APPENDIX 2 – RECOMMENDED TRACK CHANGE AMENDMENTS TO THE PLAN CHANGE

RECOMMENDED TRACK CHANGE AMENDMENTS TO PLAN CHANGE

Changes to the Waipā District Plan arising from PC33 and the recommendations of the s42A report are set out in the table below under the following sections:

Figure 1: Land outside of Area 7 where notations shown on the Proposed Area 7 Structure Plan (S5.9.X) are recommended to be deleted.

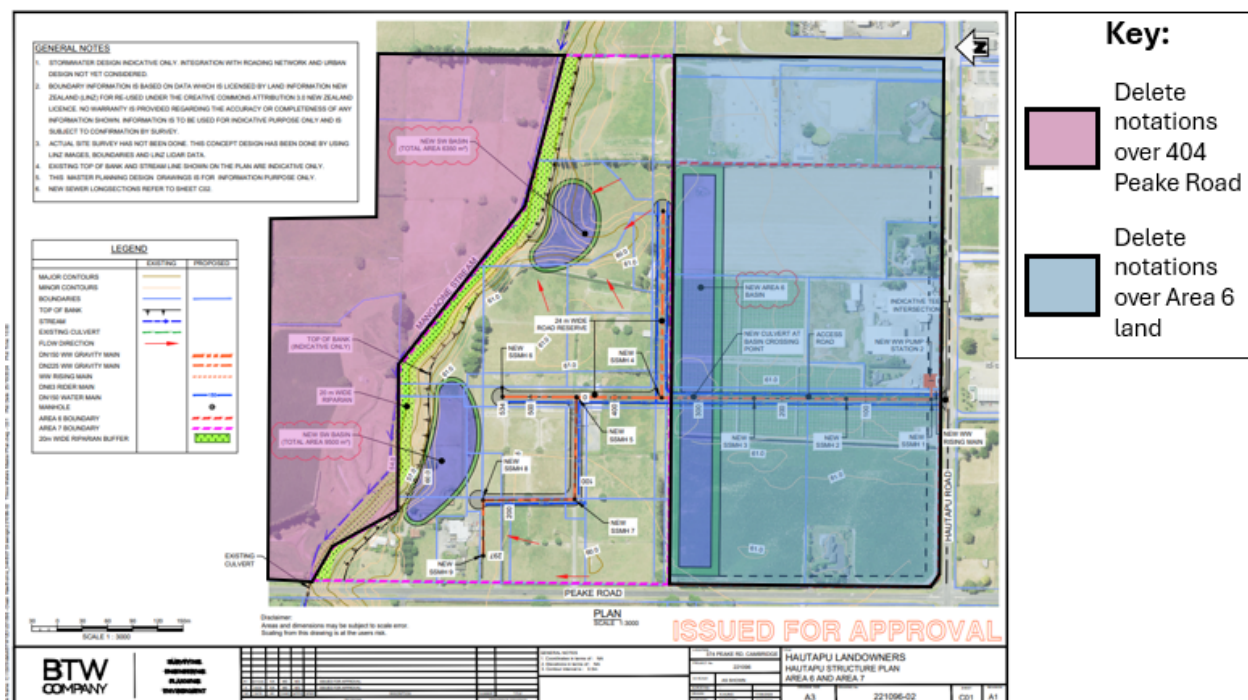
Proposed Area 7 Structure Plan (S5.9X):

- Add advice note as follows: ~~Development within Area 7 is subject to both the Hautapu Industrial Structure Plan (S5.9) and the Area 7 Structure Plan (S5.9.X). [4/7, FS 1/20]~~
- ~~Remove “20m Wide Riparian Buffer” notation from Rural Zone properties outside of Area 7. [1/1, FS 1/1, 4/6, FS 1/19]~~
- ~~Remove any notations over Area 6. [4/6, FS 1/19]~~
(Refer Figure 1 below)
